QUIKTRIP NO. 4245 SITE PLAN WITH CONDITIONAL USE

LOCATED AT THE NORTHEAST CORNER OF E ALAMEDA AVE AND S CRYSTAL STREET
 LOCATED IN THE SW QUARTER OF SECTION 7, TOWNSHIP 4 SOUTH, RANGE 66 WEST OF THE 6TH PRINCIPAL MERIDIAN
 CITY OF AURORA, COUNTY OF ARAPAHOE, STATE OF COLORADO

Comments in green were made by PW Engineering reviewer Sergio Um. Please contact him at sum@auroragov.org for any comments or questions.

5 CMU BLOCK SEATWALL

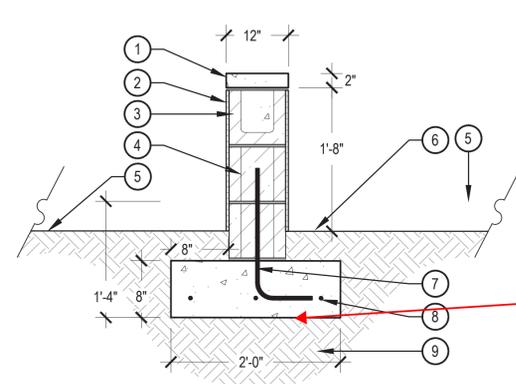
Include an elevation/detail of the proposed wall along E. Alameda. Specify color, material and height. If it is being provided on a civil drawing plan set, include it here as staff doesn't have access to the civil drawing files.

SEATWALL DETAIL ADDED

SHEET TITLE:
 PHOTOMETRIC PLAN

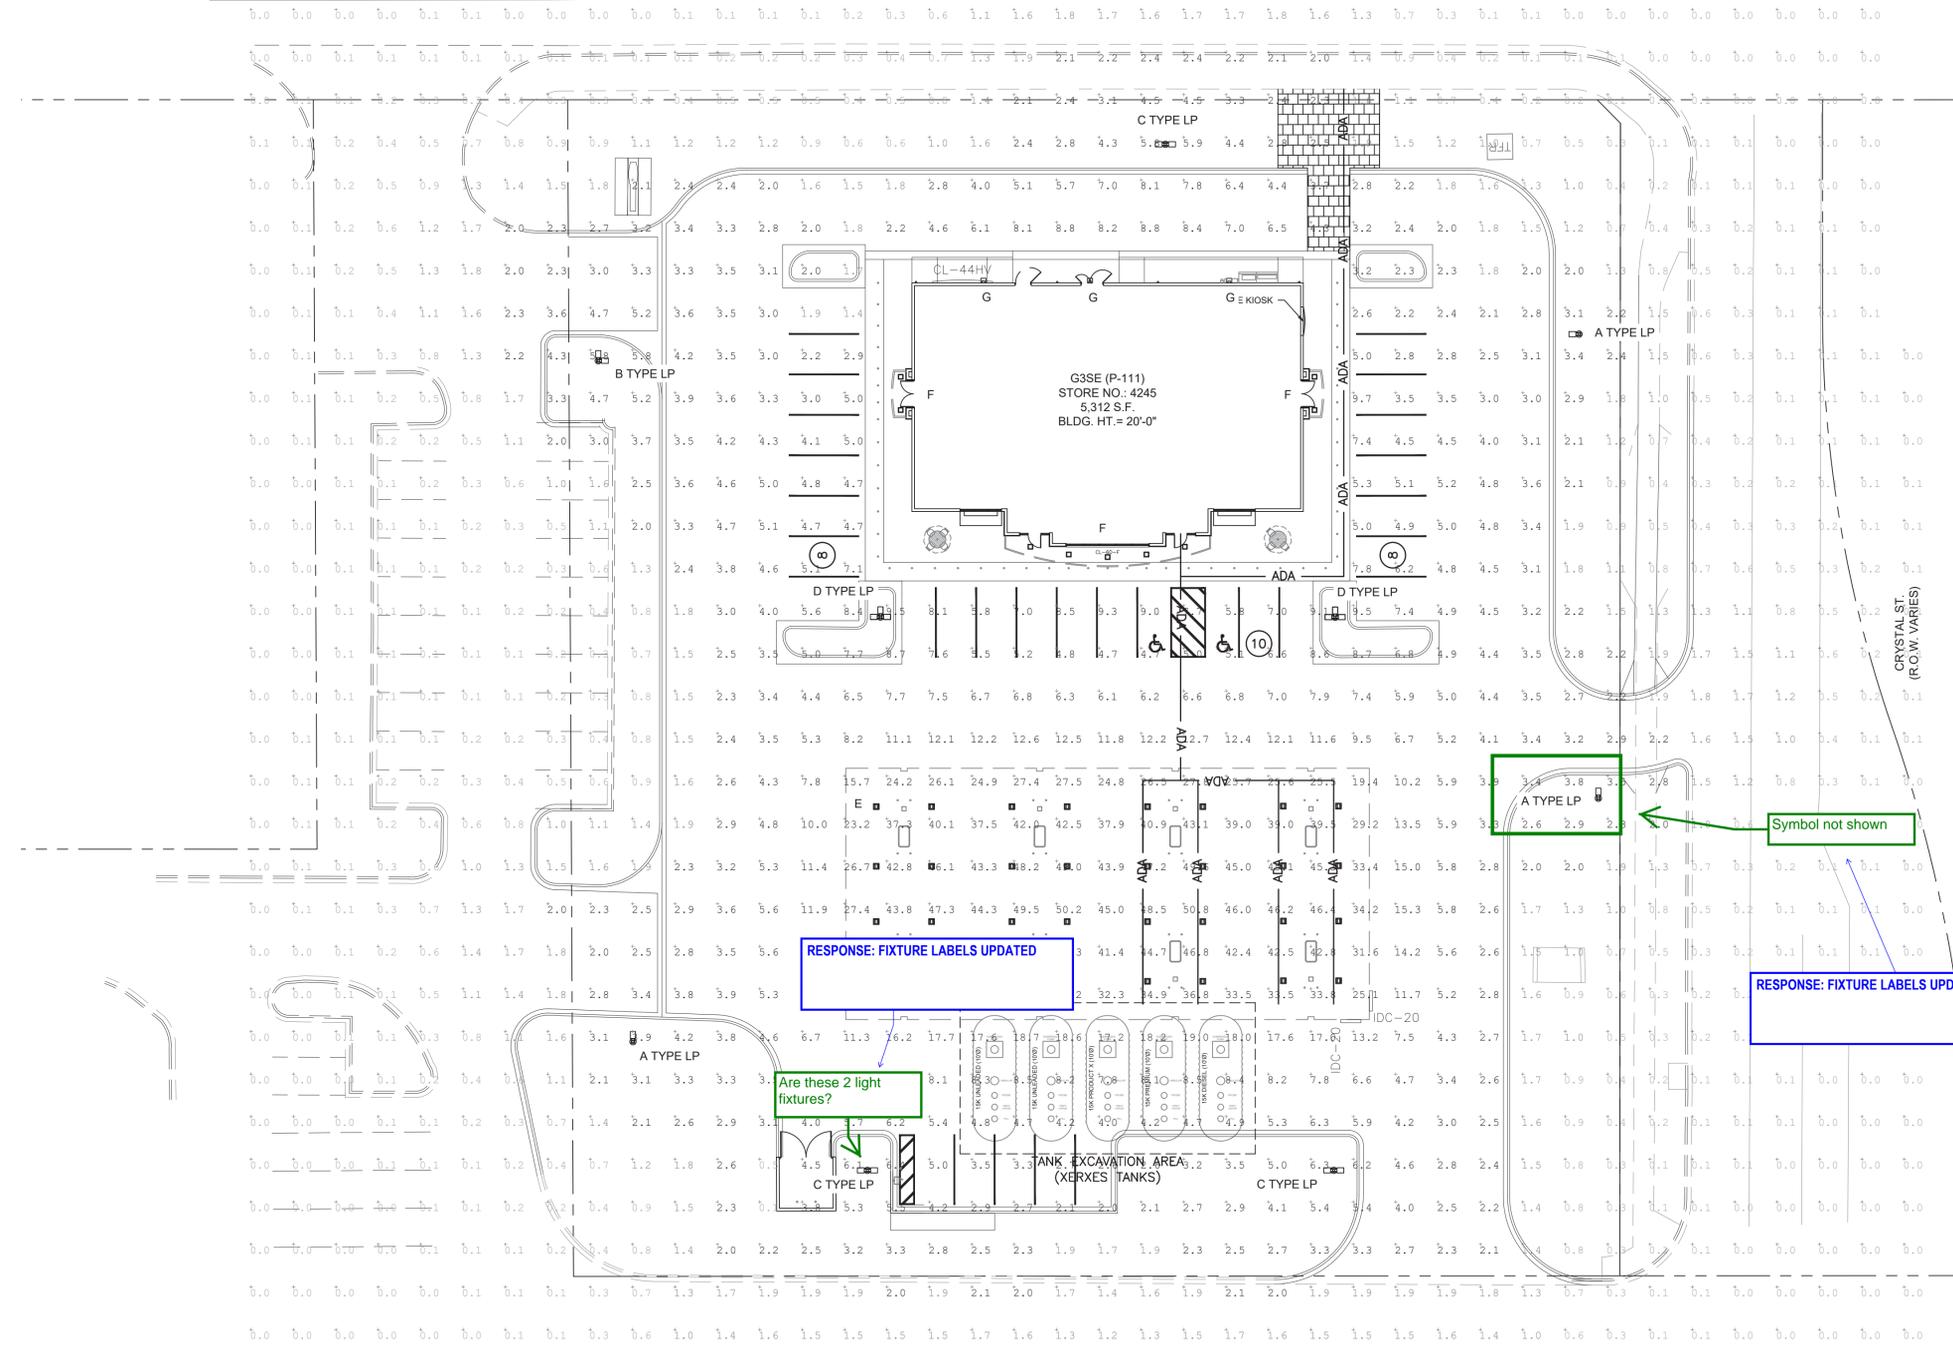
Grading plans do not show some of the light fixtures shown on this sheet, some locations are off as well.

Symbol not shown

Are these 2 light fixtures?

RESPONSE: PHOTO AND GRADING BASES HAVE NOW BEEN COORDINATED

RESPONSE: FIXTURE LABELS UPDATED

RESPONSE: FIXTURE LABELS UPDATED
